P&Z STAFF REPORT

Board of Appeals Hearing; July 10, 2018

Case: **V18-0010 – 336 Hammond Dr & 6049 Boylston Dr**

Report Date: June 26, 2018

SITE PLAN

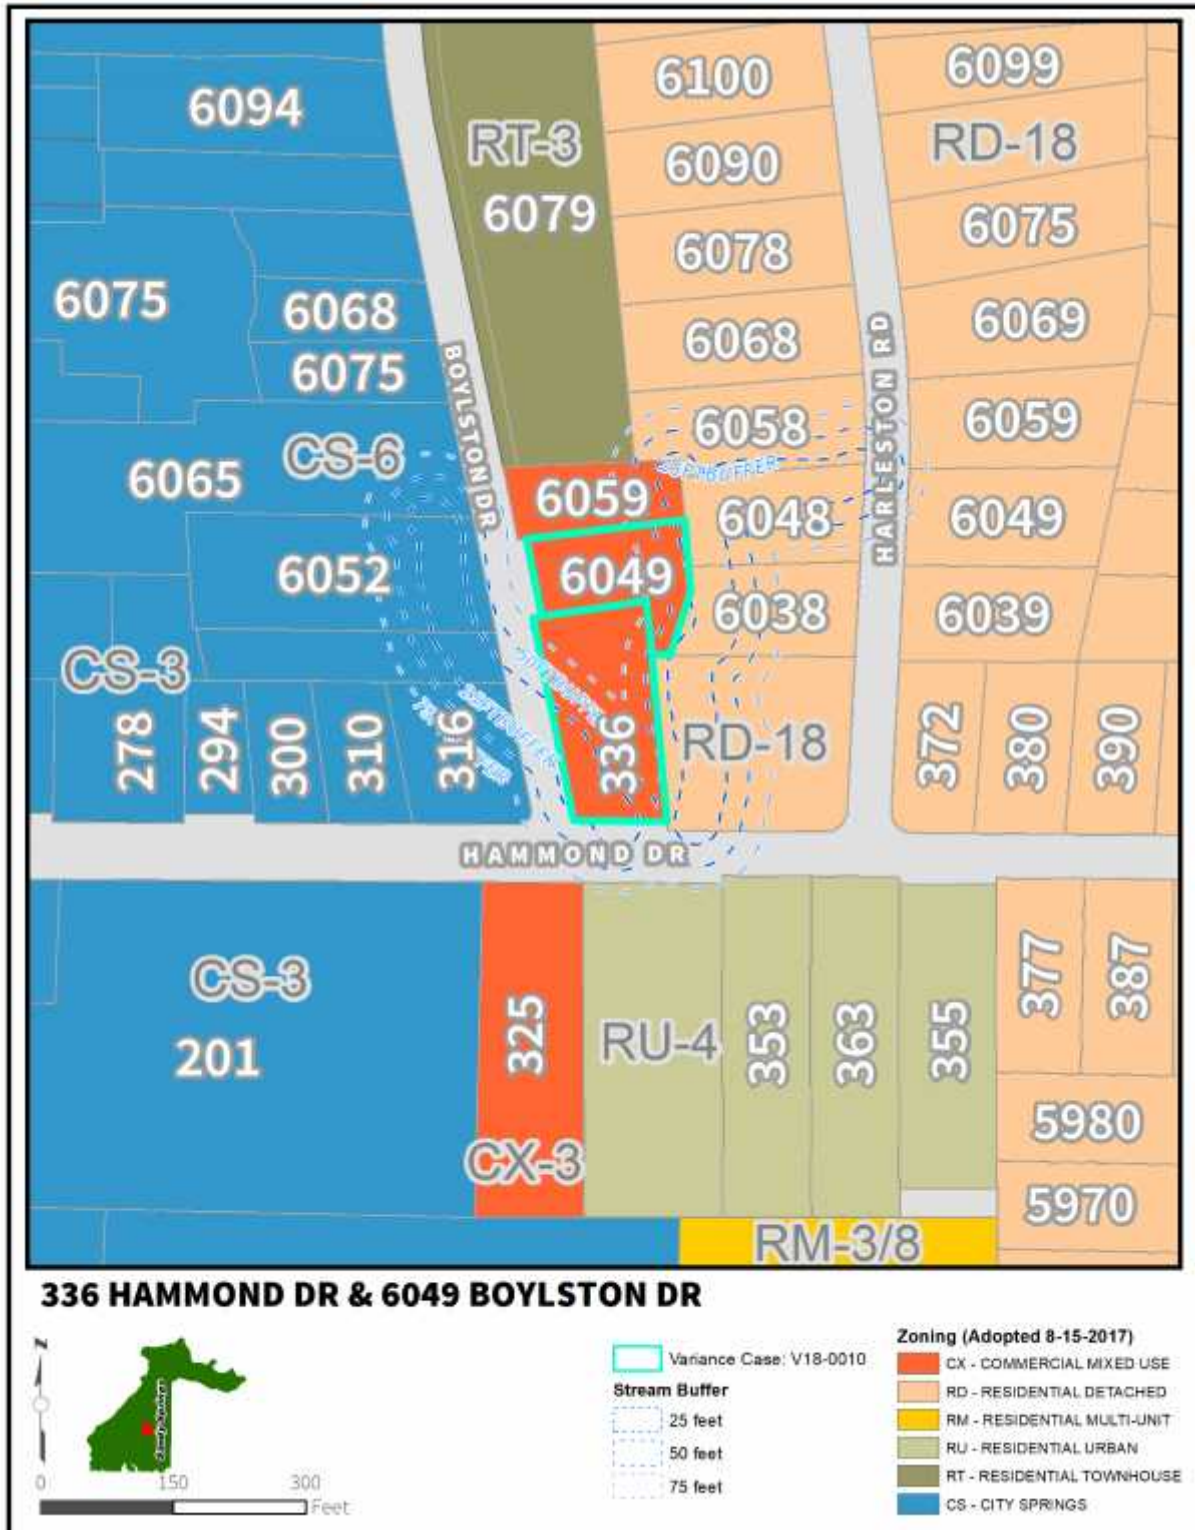
Findings: As proposed, parts of the parking area encroach into the 25-foot Protected Neighborhood transition buffer. For the most part the applicant is proposing to maintain an existing encroachment with only a roughly 5 deep' by 15' wide sliver of new encroachment (approximately 75 sf total). At the same time, the applicant is proposing to remove an 80' wide by 3' deep encroachment (approximately 24 sf), for a small net reduction of Protected Neighborhood buffer encroachment. Staff finds that due to the overall area reduction of the Protected Neighborhood buffer encroachment there is no anticipated impact on adjacent property and that the applicant has limited his request to the minimum relief necessary to make reasonable use of the property.

Findings: Sec. 8.1.8.B of the Development Code requires parking lot landscape islands to be a minimum of 200 square feet, while the applicant proposes 138 square feet for the two required landscape islands (see site plan on page 3 for reference). Reducing the minimum width of landscape islands allows to move the parking lot forward and further away from the stream. Due to approximately two thirds of the site being covered by stream buffers and the City's impervious surface setback, Staff finds that there are extraordinary and exceptional conditions present that would lead to an unnecessary hardship to the petitioner without a variance.

Findings: Sec. 4.4.2.H of the Development Code requires all parking to be at least 20 feet behind a side street property line to allow for safe circulation patterns and a visual separation between the street and a surface parking lot. Due to approximately two thirds of the site being covered by stream buffers and the City's impervious surface setback, Staff finds that there are extraordinary and exceptional conditions present due to the topography present. In response, the applicant is proposing to move the parking area away from the stream and forward towards the street. The applicant is meeting, but not exceeding the City's minimum dimensional standards for aisle width and parking stall depth and width. Therefore, Staff finds that the applicant's proposal reflects the minimum relief necessary to make possible the reasonable use of the property.

Findings: The City requires a minimum distance of 25 feet for uninterrupted ingress/egress between the right-of-way line and the nearest edge of the parking space to allow for safe circulation patterns on a site. 25 feet allows for one car to pause safely on the site while waiting for another car to back out of a parking space. Any less distance would have a portion of a car hang out into Boylston Drive, creating an unsafe situation. The applicant is proposing to reduce the distance to 7.5 feet; substantially less than required to safely accommodate a car. Therefore Staff finds that the proposal would be detrimental to public safety. Staff therefore recommends **DENIAL** of this Variance request.

RECOMMENDATION
Department of Community Development
Staff recommends <u>APPROVAL</u> of Variance requests # 1, 2, 3, 4, 5, and 6, and <u>DENIAL</u> of Variance request #7 contained in V18-0010.
